DRAINAGE SUMMARY

PROJECT: MAUNALOA HIGHWAY, REPLACEMENT OF CULVERTS BETWEEN
MAUNALOA VILLAGE AND KAUNAKAKAI - PHASE II
PROJECT NO. RS-0460(3)

STATE OF HAWAII
DEPARTMENT OF TRANSPORTATION
HIGHWAYS DIVISION

Replacement of Culverts bet. Maunaloa
Village and Kaunakakai - Phase II

DETAILS OF 30 AND 42 INCH CULVERTS AT STA. 16+59.79 AND STA. 70+25

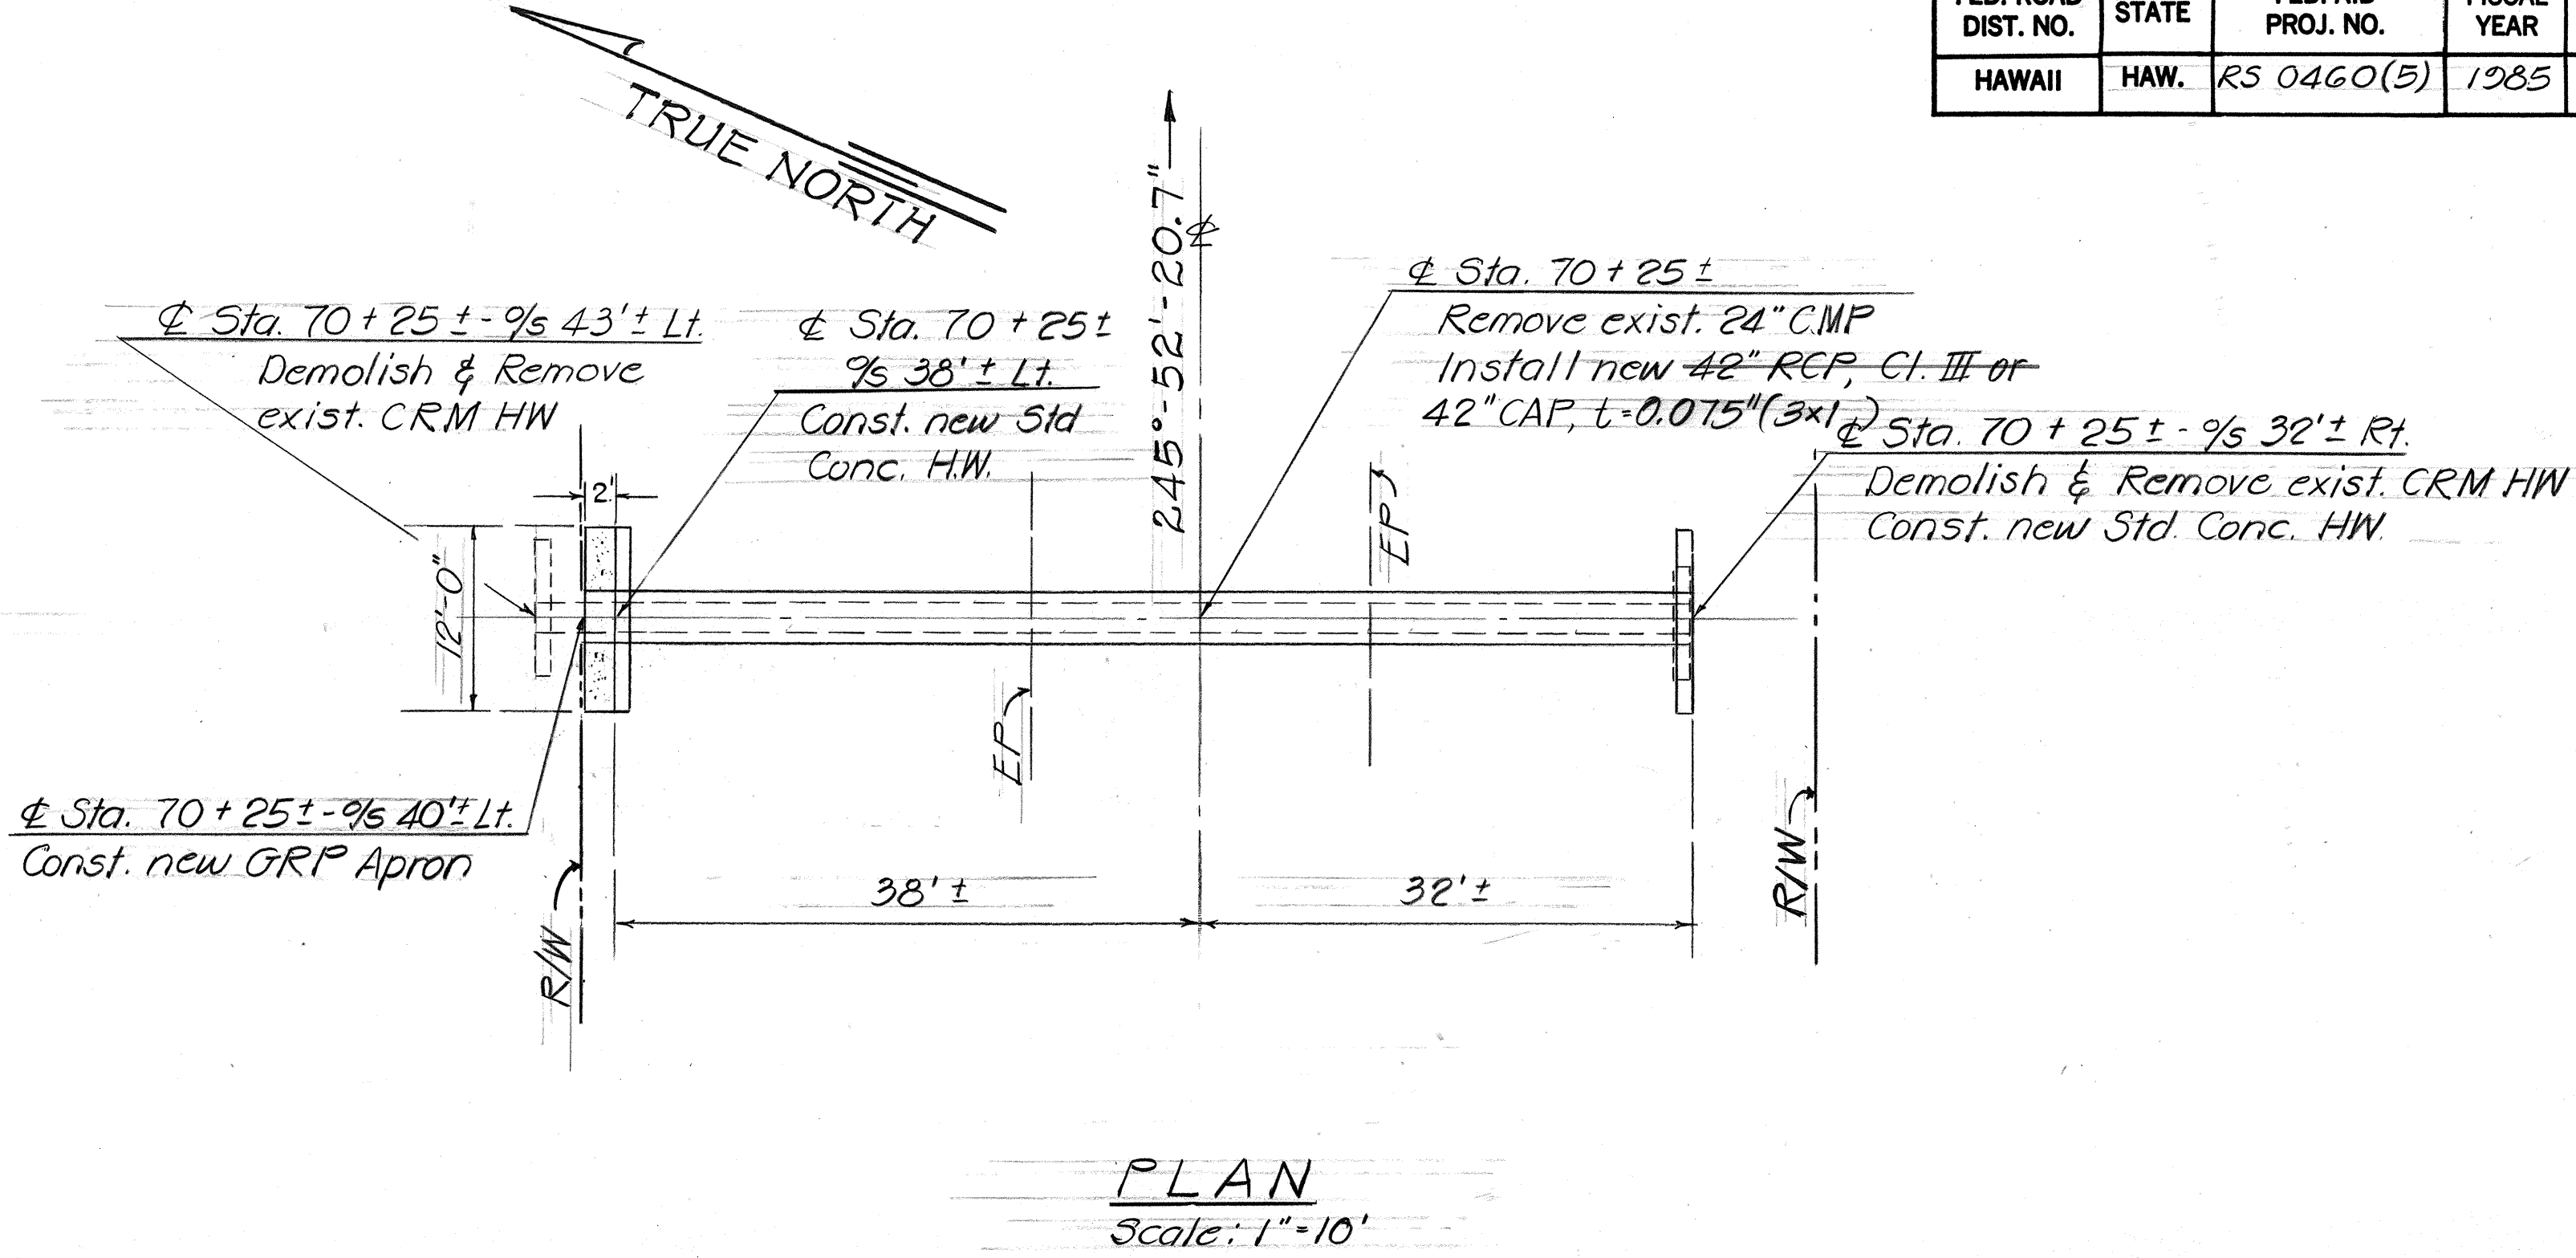
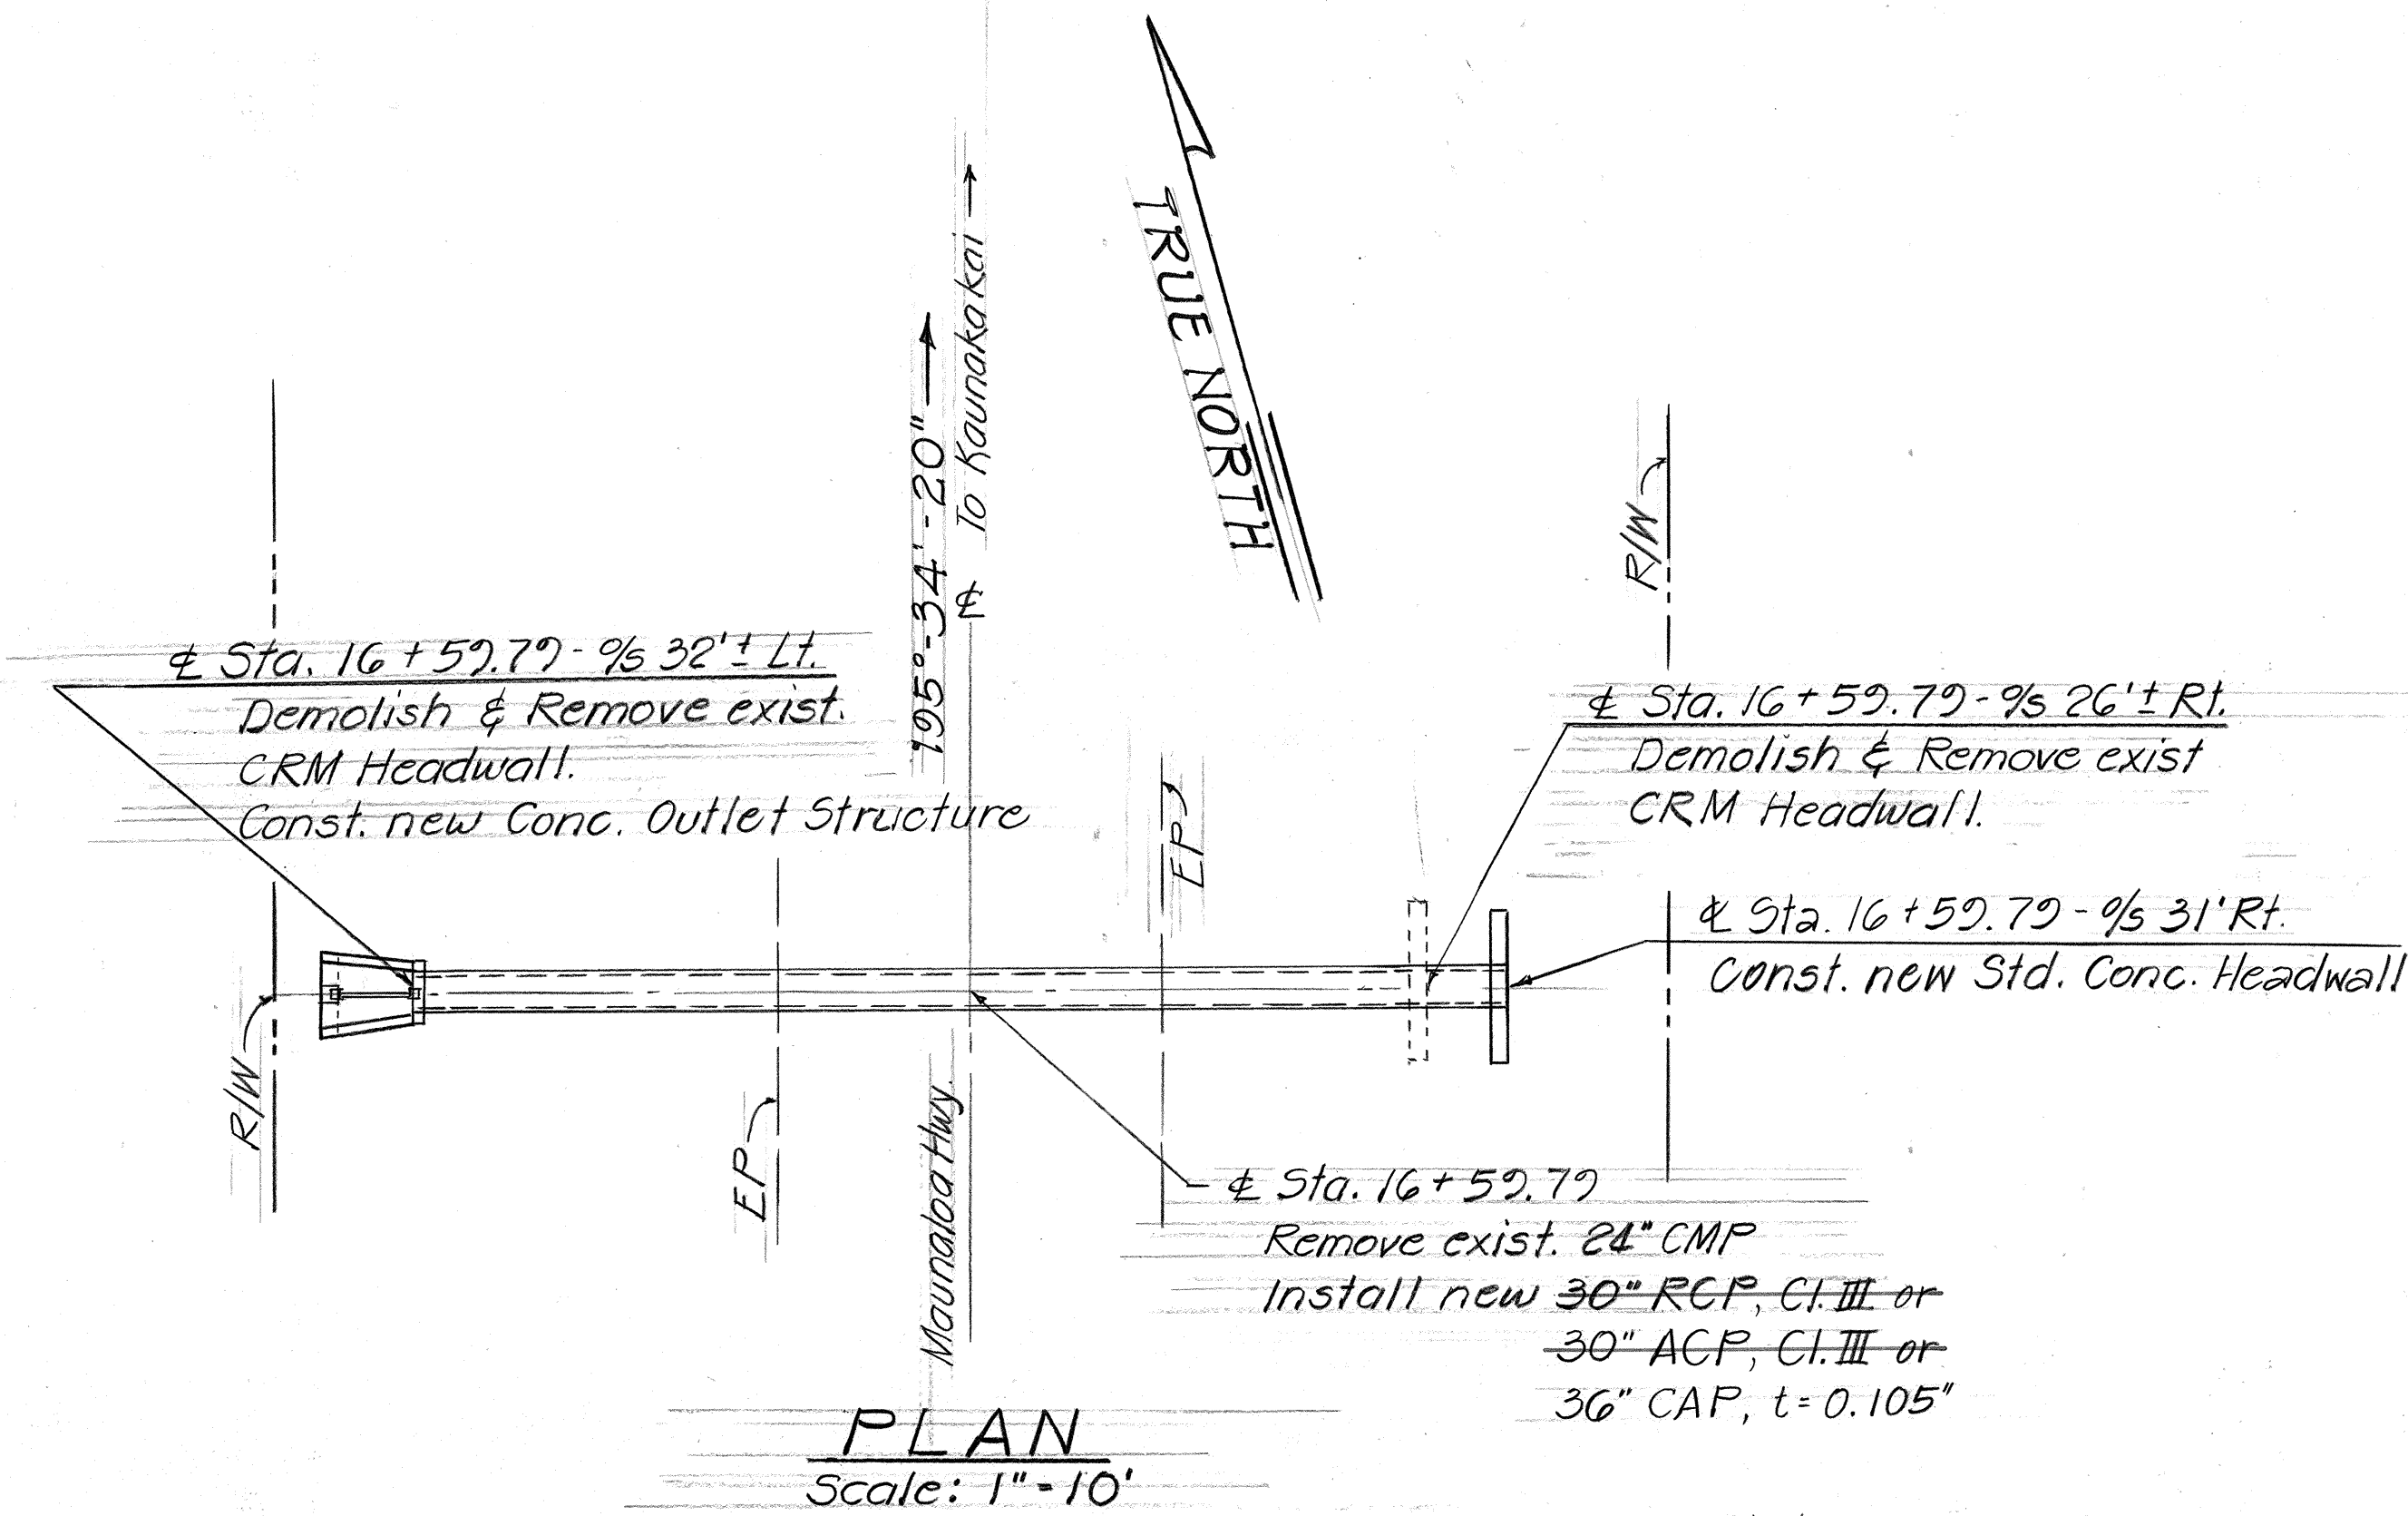
10/23/84	Per Addendum No. 1 Change 42" CAP t=0.105" to 42" CAP, t=0.075" (3x1)
DATE	REVISION
